South Texas Project
Units 1 & 2
Docket Nos. STN 50-498, STN 50-499
NRC Question Responses

South Texas Project
Units 1 & 2
Docket Nos. STN 50-498, STN 50-499
NRC Question Responses

NRC Q251.13N (SRP 5.3.1)

NRC Q251.14N (SRP 5.3.1)

Reactor Coolant System Heatup
 Limitations Applicable to 32EFPY
 Figure 251.14N-1

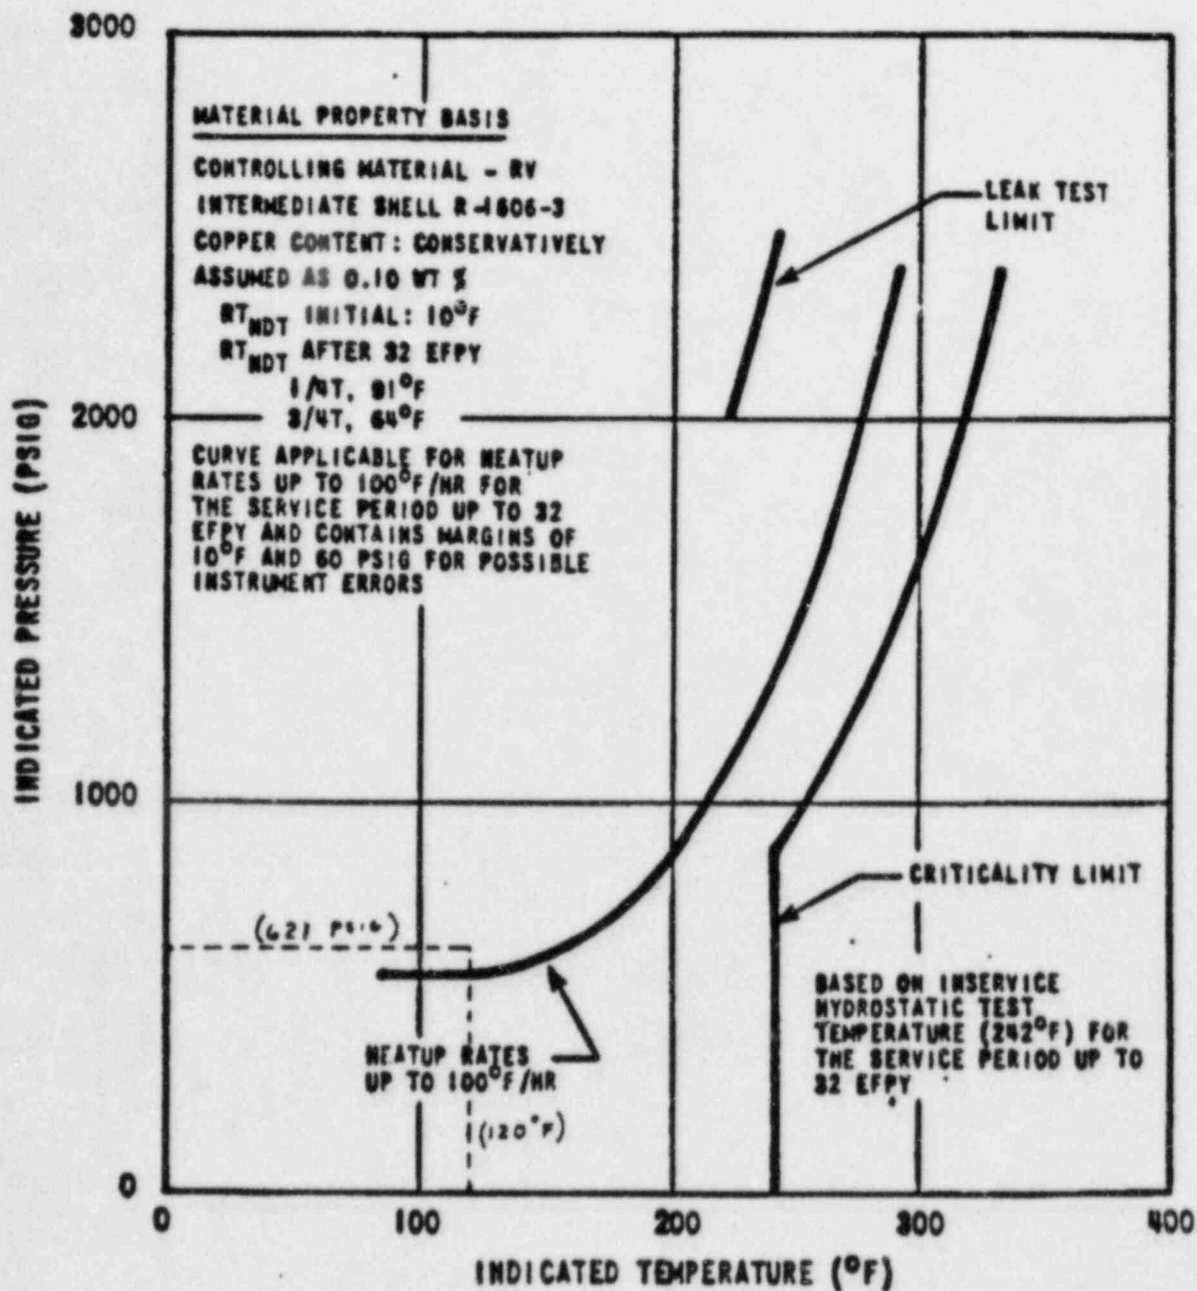
To demonstrate compliance with Appendix G, 10 CFR Part 50, as revised May 27, 1983 (48 FR 24009), submit fracture mechanics analyses, or pressure-temperature limit curves for the closure flange region of the Unit 1 and Unit 2 reactor pressure vessels.

The new 10 CFR 50 Appendix G rule states that the minimum metal temperature of the closure flange regions should be at least 120° higher than the limiting RT_{NDT} for these regions when the pressure exceeds 20 percent of the preservice hydrostatic test pressure (621 psig for Westinghouse plants). For South Texas Unit 1 the minimum temperature of the closure flange and vessel flange regions is 120°F since the limiting RT_{NDT} is 0°F (see FSAR Table 5.3-3). The South Texas Unit 1 heatup curve shown in Figure 251.14N-1 is not impacted by the new 10 CFR 50 rule. However, the current South Texas Unit 1 cooldown curve is impacted by the new 10 CFR 50 rule. A revised Unit 1 cooldown curve which meets the Appendix G requirement (see Figure 251.14N-2) will be provided in the Technical Specifications.
